Stage 01: Modification Proposal

GC0118:

Mod Title: Modification to the Grid Code to accommodate the recent Distribution Code modification to Engineering Recommendation P28 – *Voltage fluctuations and the connection of disturbing equipment to transmission systems and distribution networks in the United Kingdom.*

Purpose of Modification: The purpose of this modification is to ensure the Grid Code implements the proposed changes as set out in the revised Engineering Recommendation P28 Issue 2 (2018) (subsequently referred to as EREC P28 Issue 2).

Figure CC.6.1.7 -
Time and magnitude limits for a category 3 Rapid Voltage Change

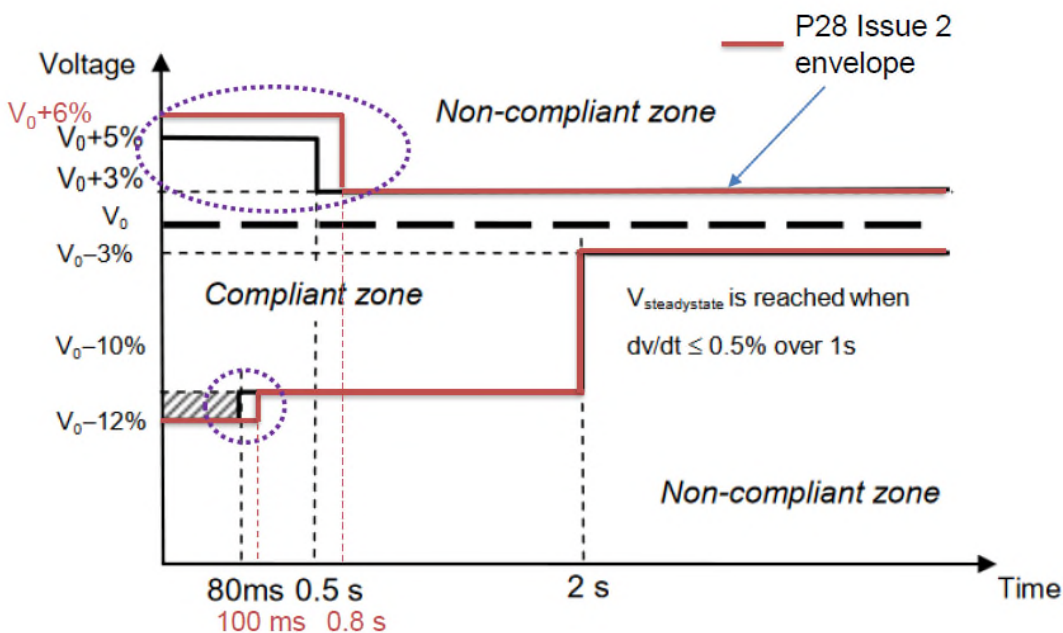
- Allowable voltage changes are expressed as a percentage of nominal voltage (V_n) in P28 Issue 2 as opposed to a percentage of the initial voltage (V_0) in the Grid Code. The intention being to align with the approach taken in National and International Standards.
- For increases in voltage:

- EREC P28 Issue 2 proposes a limit on the maximum voltage change between two steady state conditions of $\Delta V_{\max} \leq 6\%$ for a maximum duration of 0.8 s from the initiation of a voltage change.

- The Grid Code has a limit of $\Delta V_{\max} \leq 5\%$ for a maximum duration of 0.5 s.
- For decreases in voltage:
 - EREC P28 Issue 2 proposes a time limit of 100 ms from initiation of a voltage change during which the maximum voltage change permitted (-12% for 'very infrequent events' and -10% for 'infrequent events') can persist.

- The Grid Code has a time limit of 80 ms from initiation of a voltage change during which the maximum permitted voltage change is -12%.
- For increases and decreases in voltage, EREC P28 Issue 2 permits a greater maximum number of occurrences for Category 3 'very infrequent' events:

The difference between the voltage envelope for Rapid Voltage Changes in Figure CC.6.1.7 of the Grid Code and Table 4 of EREC P28/2 Issue 2 for Very Infrequent

RVCs are shown in the above figure. The P28 Working Group has proposed limits for RVC in EREC P28 Issue 2 that:

- generally align with those in Figure CC.6.1.7 for reductions in voltage.
- are absolute and compatible with EREC G59 and grid connected protection as well as TGN 288 for overvoltage.
- are compatible with immunity levels for customer equipment.
- should not result in unacceptable disturbance provided:-
 - events are sufficiently spaced apart.
 - multiple RVCs are completed within a small time window.
 - there is no damage to or tripping of customer equipment.
